#2013-14 Anderson VW

Project Review for Planning and Zoning Commission

Requests: Variations for landscaping and lighting for an auto dealership.

Location: 5213 Northwest Highway

CRYSTAL LAKE - VOLKSWAGEN SITE PLAN
3DEC, 2012 ANDERSON

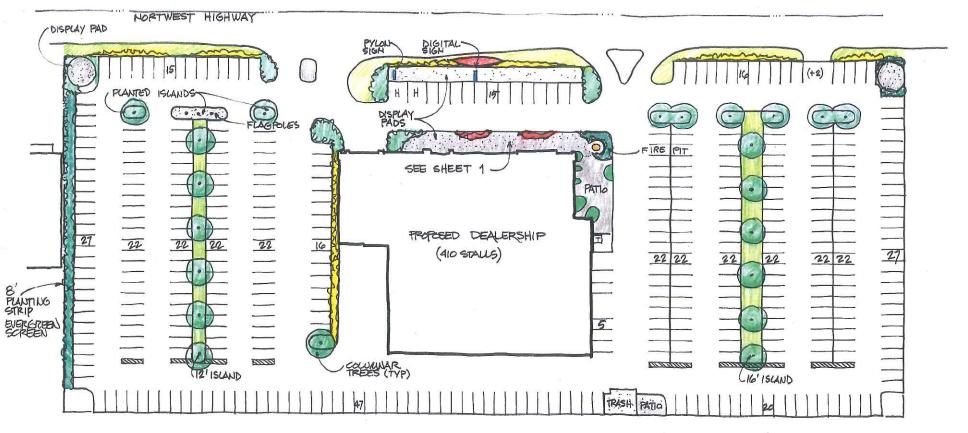
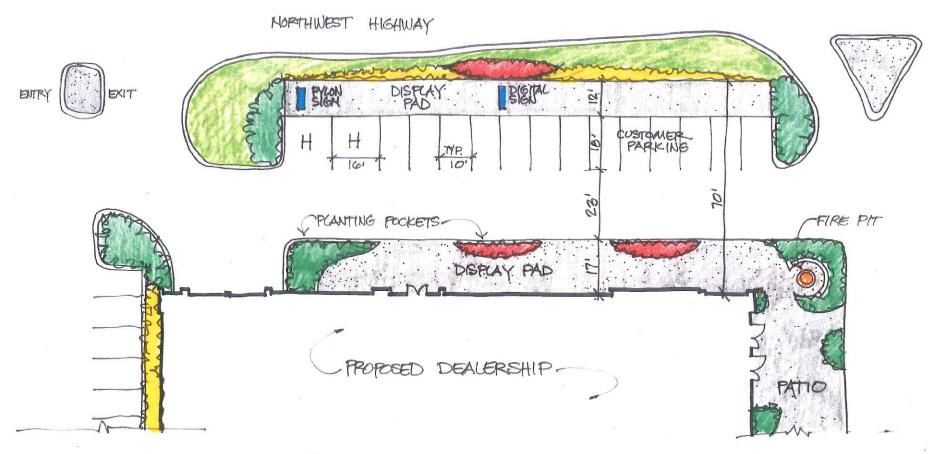
- <u>Details:</u> How the site lays out would basically stay the same. The shallow depth of the lot and the City's building and slope setbacks limit how this site can be arranged. The existing building would be demolished to make way for a new 30,494 square foot VW auto dealership. The front customer parking spaces and vehicle storage areas on either side of the principal building would basically remain the same. The petitioner's engineers have worked closely with the City to meet the requirements of the City's slope stabilization study and other code requirements.

<u>Parking:</u> Customer parking is shown on the north and west sides of the building, to accommodate car shoppers and service customers, respectively. The spaces provided meet the UDO requirements for this use.

TING PHOTOMETRIC PLAN

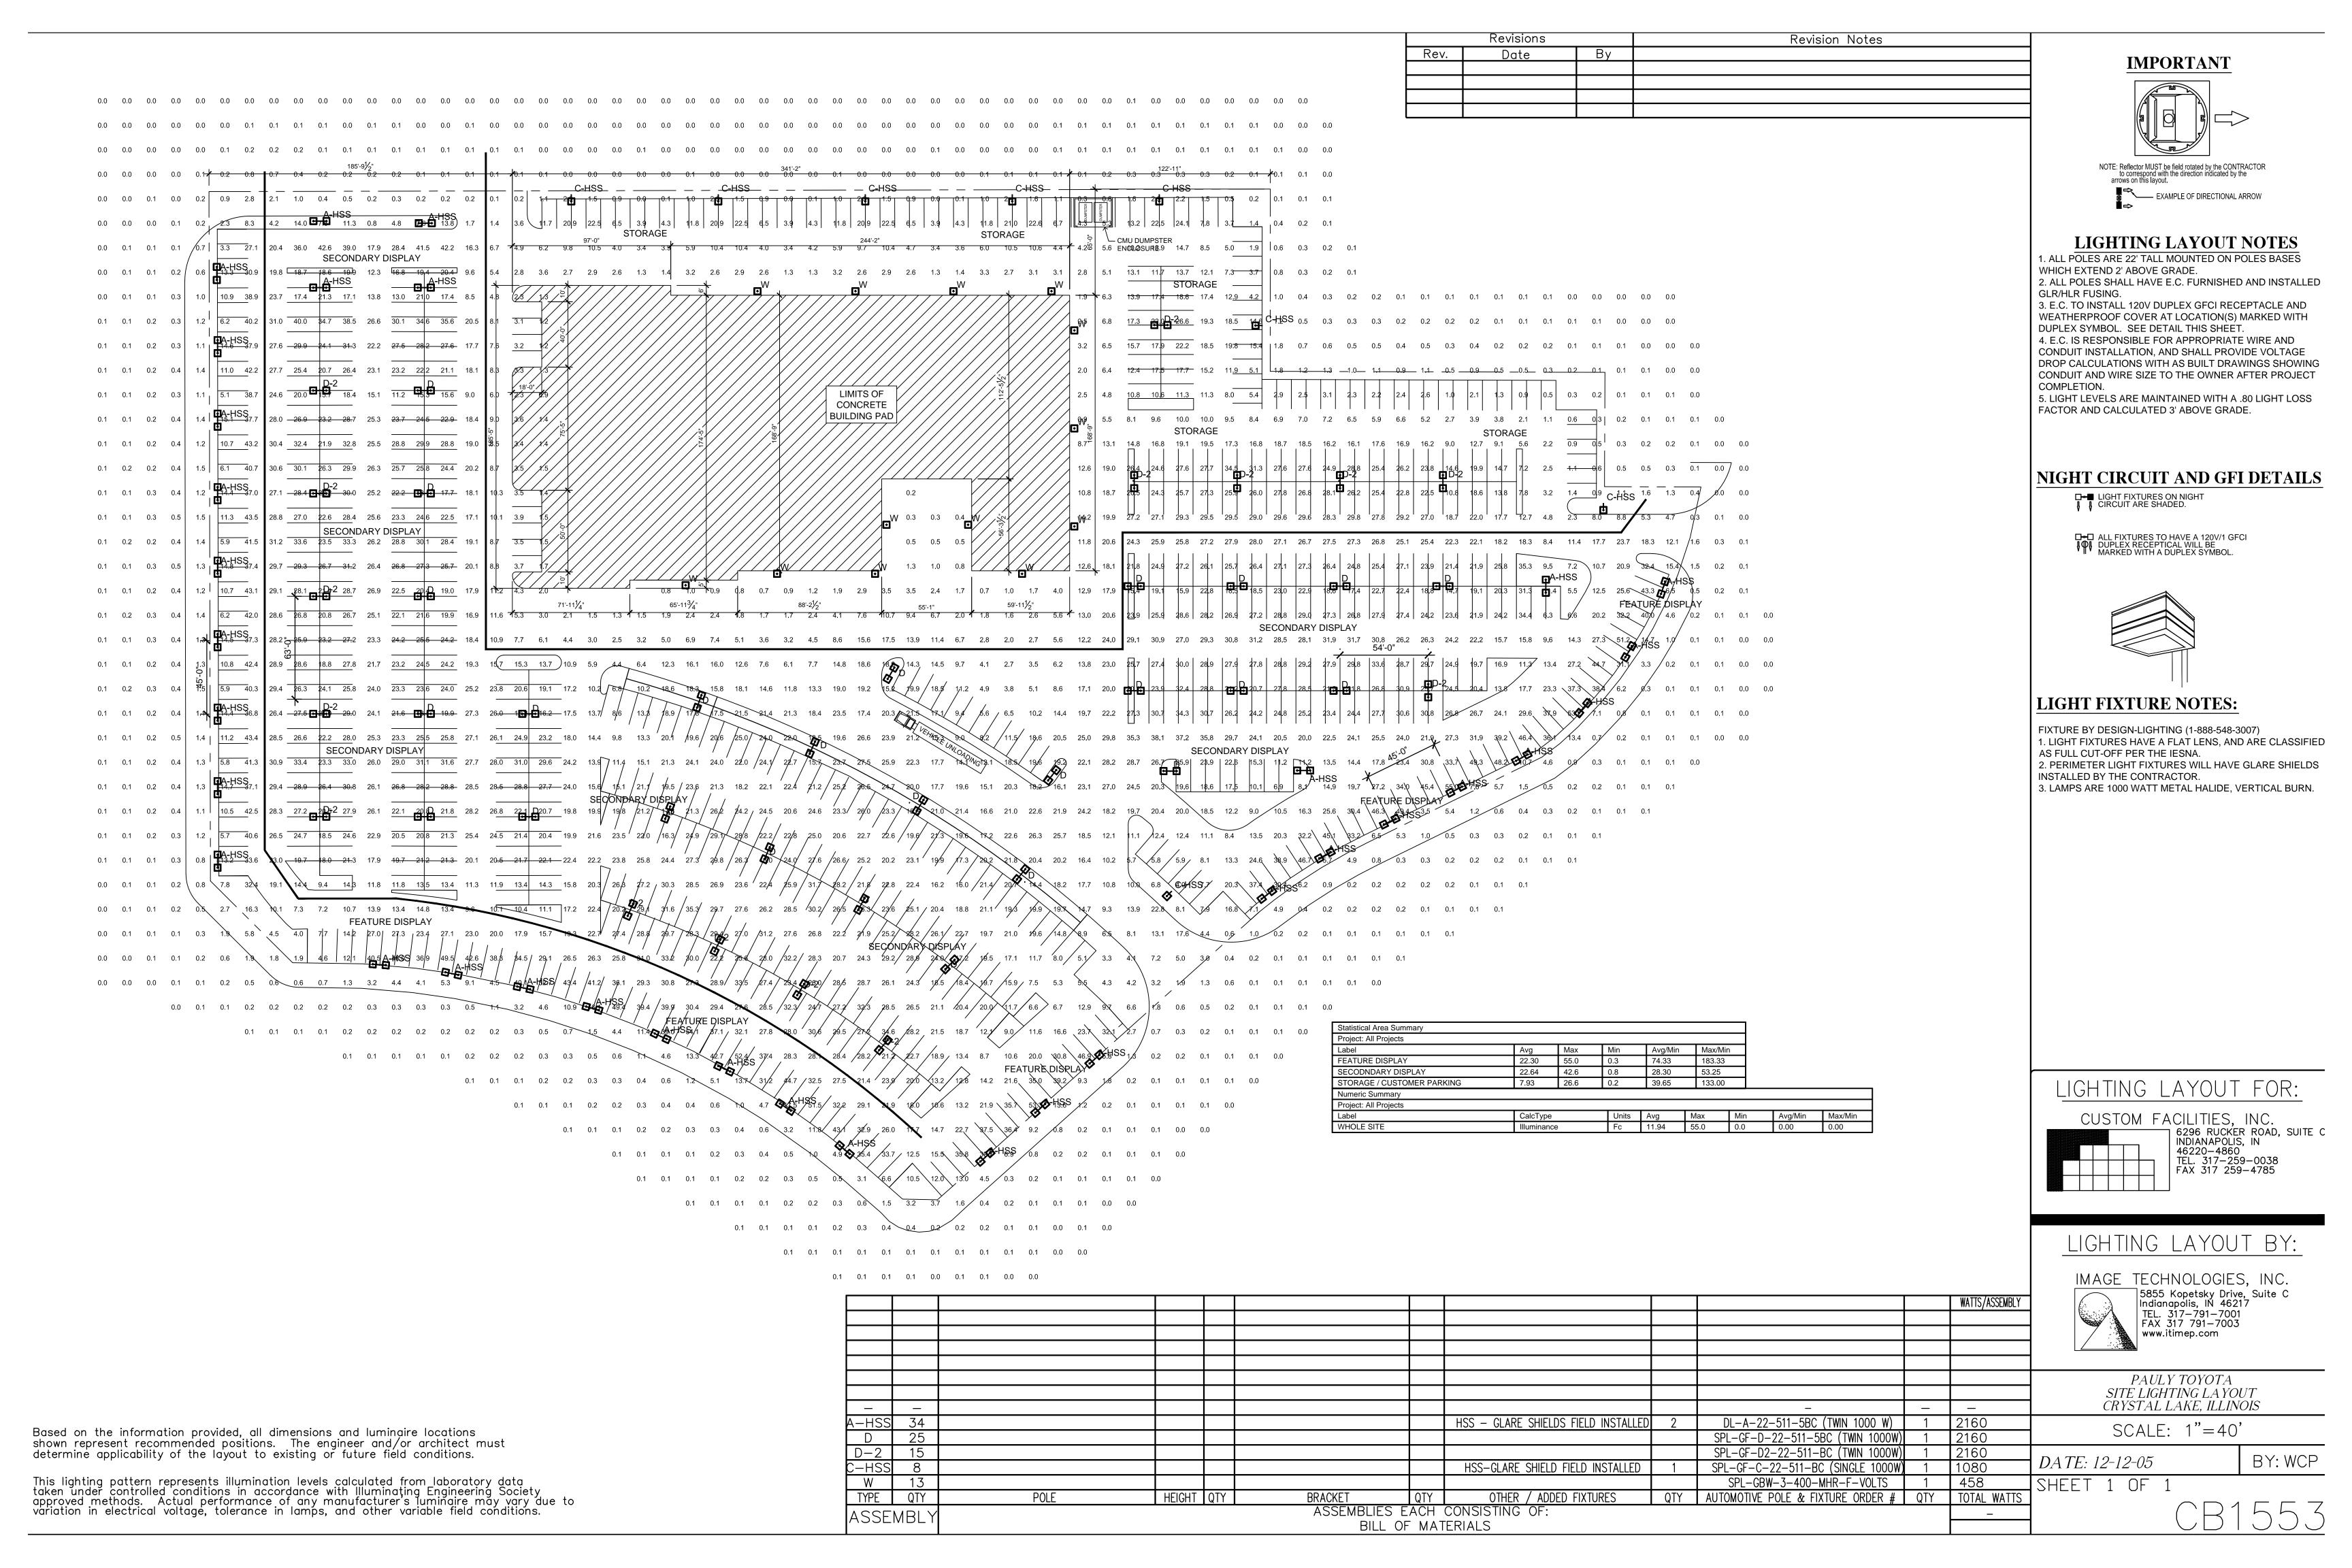
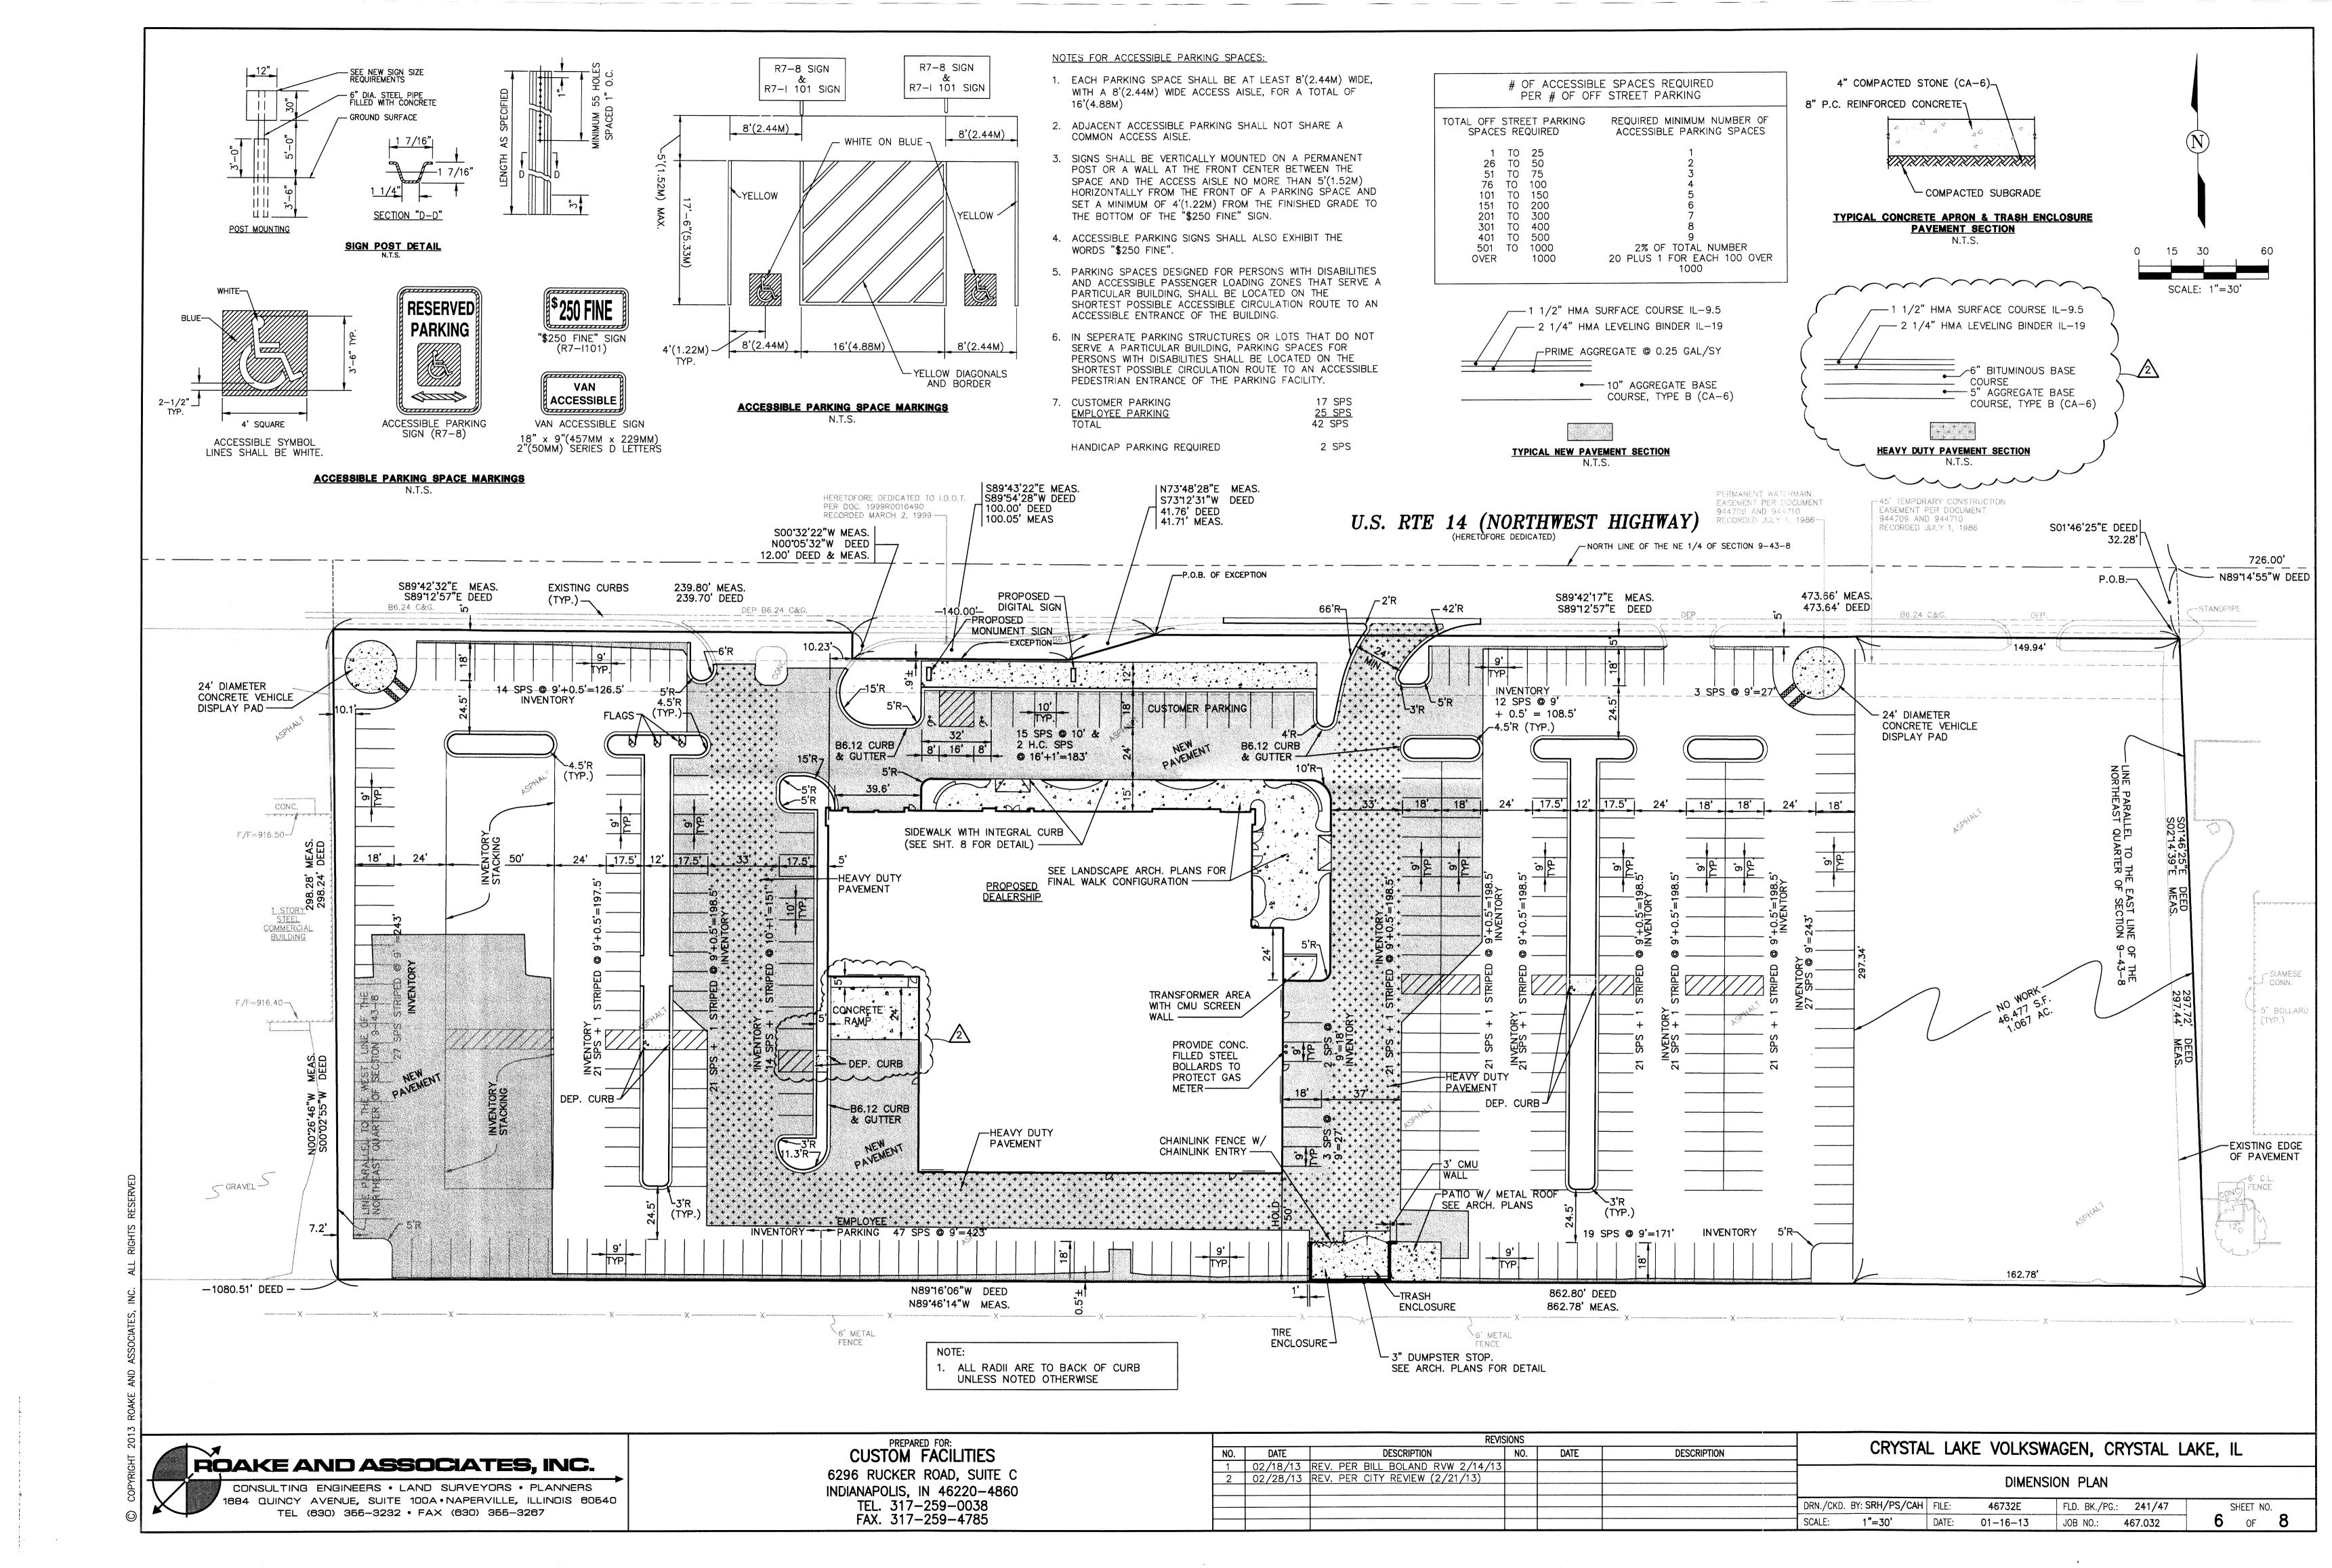
There are two facets to this request: site and building lighting. The site is held to overall illumination levels that have been implemented by the UDO for auto dealerships. The requirement is 20 maximum average footcandles (fc) for front row display and 10 maximum average fc for the remaining display areas. The plan shows up to 52 fc for the front row and 25-35 fc for the other areas. This correlates almost exactly to what Pauly Toyota has on their site.
